# TECHNICAL INFORMATION JDE

Type <b>Coffee Vending Machine</b>	Model <b>9100</b>	T.I. NO <b>09 - 2017</b>	
Serial Number <b>74312486</b>	Subject <b>Z4000 ES-FB HOT WATER INLET IMPROVEMENTS</b>	ISSUED FOR (X)	Action Information <b>X</b>

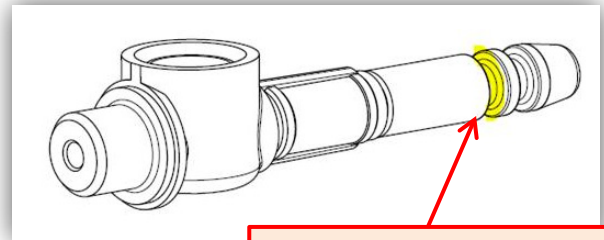
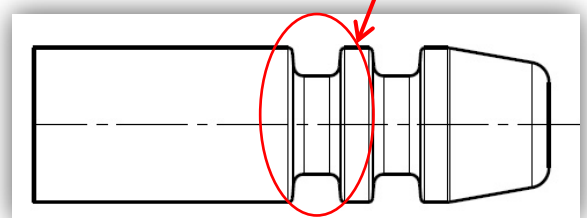
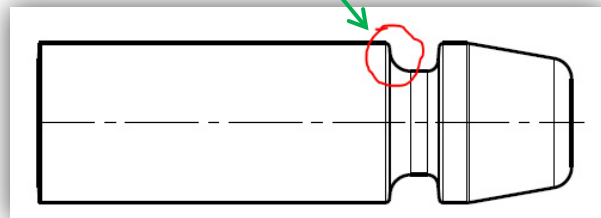
The O-ring seat (marked in yellow colour in the picture below) has been removed, because it is no longer used.

The radius of the gasket seat has been increased: now it smoother then before (see the circle in red).

**O-ring seat deleted**

**Radius of the gasket seat increased**

The **new** solution is retrofittable.
